## **MARITIME SCIENCE CENTER SUBDIVISION**

APPLICATION NUMBER 16 DATE July 16, 2009

REQUEST Subdivision

## DETAIL SITE PLAN

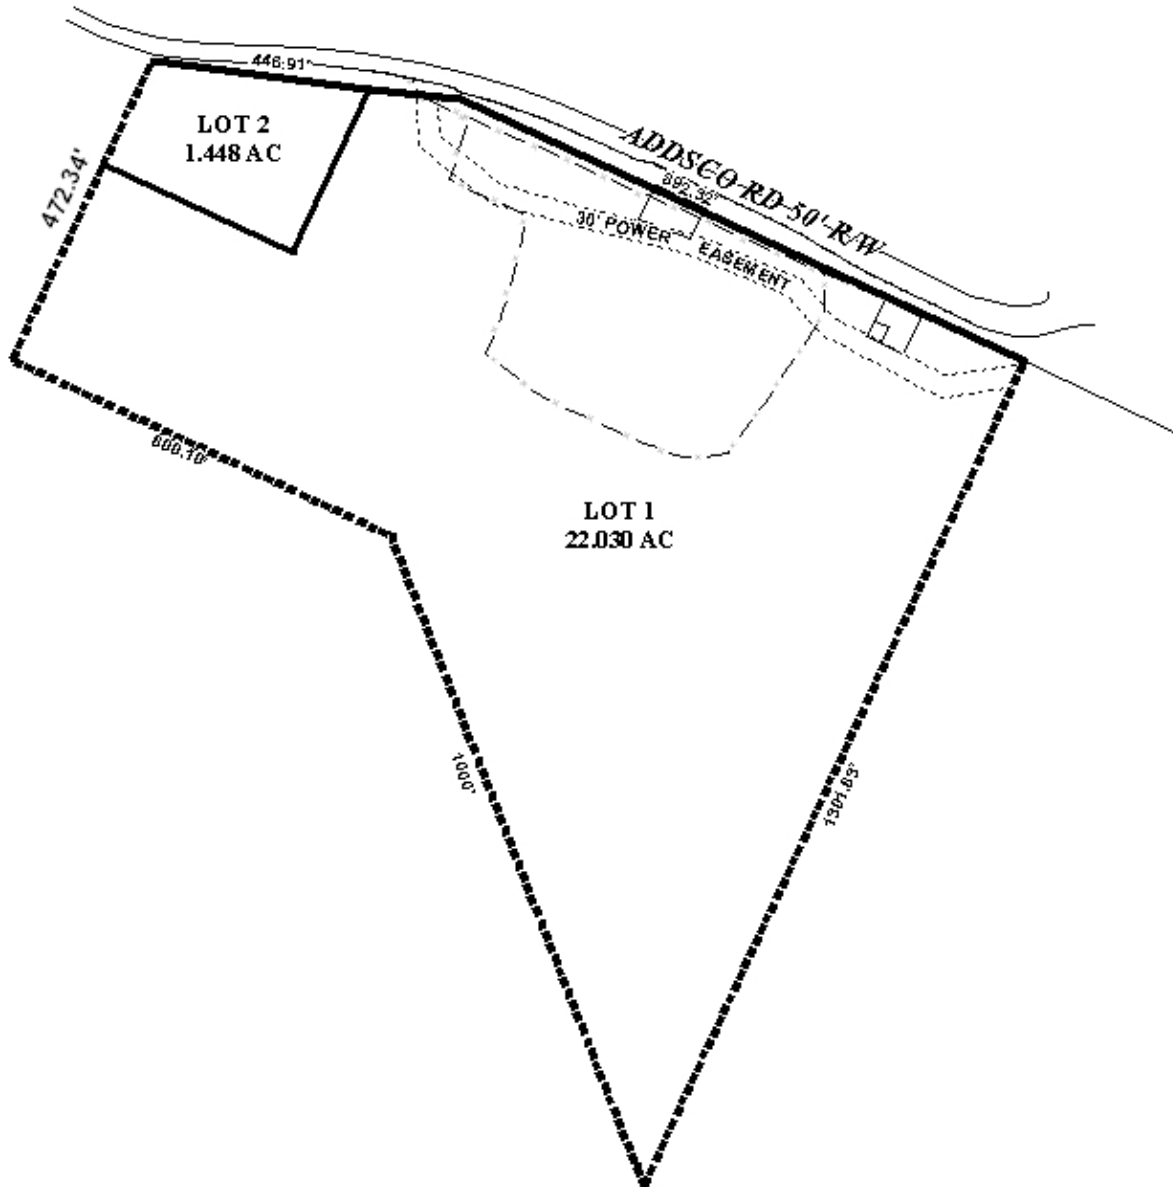
The proposed lots meet the minimum size requirements as regulated by Section V.D.2 of the Subdivision Regulations. The proposed lot size is indicated on the plat and should be retained on the final plat. The proposed lots also have adequate frontage along a public right-of-way.

The plat does not appear to depict the entire parcel as shown on the tax assessor records. A survey done for the owner and dated May 12, 1992, was provided by the applicant's representative. The survey only shows the subject property that was included in this application and not the entire tax parcel. However, as this is a survey only, and not a subdivision, it is not sufficient to warrant to exclusion of the remainder of the parcel. It should be noted that the excluded area is a dredge spoil site and likely is not useful as a building site. Accordingly, the entire parcel should be included in this subdivision request, however the remaining portion of the tax parcel should be designated either as conservation area or future development area in order to account for that land.

The proposed Lot 1 is a large site with over 1000 feet of frontage along Addsko Road. Addsko Road, while a minor street, has a high traffic volume due to the large amount of industry in the

area. Accordingly, access management is a concern. Because of this, the proposed Lot 1 should be limited to two curb cuts, with the size, location, and design of all curb cuts to be approved by ALDOT and City of Mobile Traffic Engineering, and conform to AASHTO standards. It should be noted that the proposed development on the proposed Lot 1 is only proposed to utilize two curb cuts.

The proposed Lot 2 is already developed and has one existing curb cut. As such, the proposed Lot 2 should be limited to the existing curb cut, with the size, location, and design of all curb cuts to be approved by City of Mobile Traffic Engineering, and conform to AASHTO standards.

The 25-foot minimum building setback line is not shown on the preliminary plat, but should be shown on the final plat, if approved.

The site appears to be within a FEMA recognized floodplain. The presence of floodplains indicate that the area may be environmentally sensitive; therefore, the approval of all applicable federal, state and local agencies would be required prior to the issuance of any permits.

- 1) Inclusion of the entire tax parcel on the final plat with appropriate labeling as future development or conservation area;
- 2) Depiction of the 25-foot minimum building setback line along all public right-of-way frontages;

- 3) Retention of lot size labeling in square feet;
- 4) Provision of a note on the final plat stating that Lot 1 is limited to two curb cuts, with the size, location, and design of all curb cuts to be approved by City of Mobile Traffic Engineering, and conform to AASHTO standards;

- 5) Provision of a note on the final plat stating that Lot 2 is limited to the existing curb cut, with the size, location, and design of all curb cuts to be approved by City of Mobile Traffic Engineering, and conform to AASHTO standards;

- 6) Provision of a note on the final plat stating that approval of all applicable federal, state and local agencies would be required prior to the issuance of any permits;
